Project	<b>IEEE 802.16 Broadband Wireless Access Working Group</b> < <a href="http://ieee802.org/16">http://ieee802.org/16</a> >	
Title	<b>Comments on AWD Downlink Physical Structure</b>	
Date Submitted	<b>2009-07-06</b>	
Source(s)	Yih-Guang Jan, Yang-Han Lee, Hsien-Wei Tseng, Ming-Hsueh Chuang, Jheng-Yao Lin <b>Tamkang University (TKU)</b>	yihjan@yahoo.com
	Youn-Tai Lee, Chun-Yen Hsu <b>Institute for Information Industry (III)</b>	lyt@nmi.iii.org.tw
	Shiann-Tsong Sheu <b>National Central University (NCU)</b>	stsheu@ce.ncu.edu.tw
	Whai-En Chen <b>National Ilan University (NIU)</b>	wechen@niu.edu.tw
Re:	Category: AWD comments / Area: Chapter 15.3.5 (Downlink Physical Structure)  "Comments on AWD 15.3.5 Downlink Physical Structure"	
Abstract	Comments on AWD Downlink Physical Structure	
Purpose	To be discussed and adopted by TGM for the 802.16m AWD.	
Notice	<i>This document does not represent the agreed views of the IEEE 802.16 Working Group or any of its subgroups. It represents only the views of the participants listed in the "Source(s)" field above. It is offered as a basis for discussion. It is not binding on the contributor(s), who reserve(s) the right to add, amend or withdraw m

Figure 459—Pilot patterns on stream 1 for 4 data streams

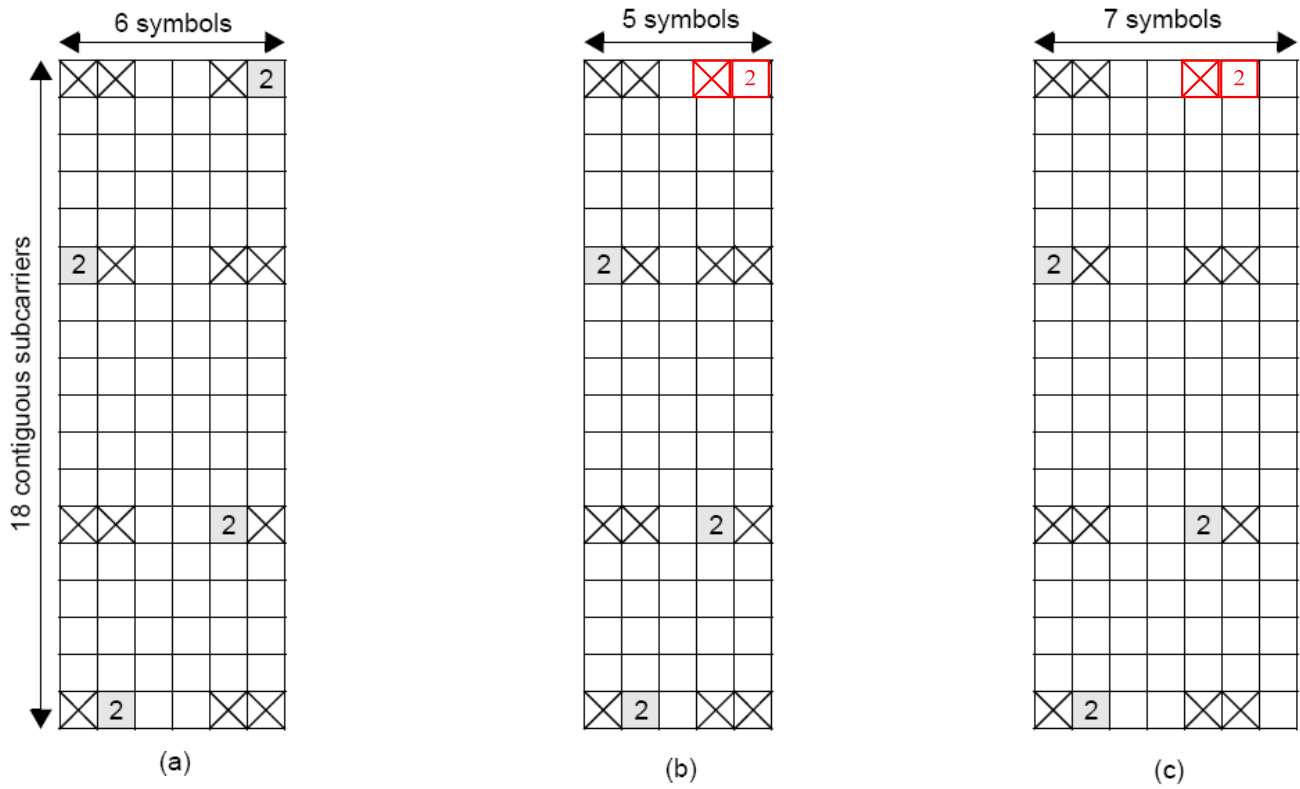
This contribution provides the corrected AWD text proposal to Pilot Patterns. In Figure 459, it has some errors and needs correction.

*[In IEEE 80216m-08\_0010r2, Section 15.3.5.4.1, replace original Figure 459 by the following corrected figure.]*
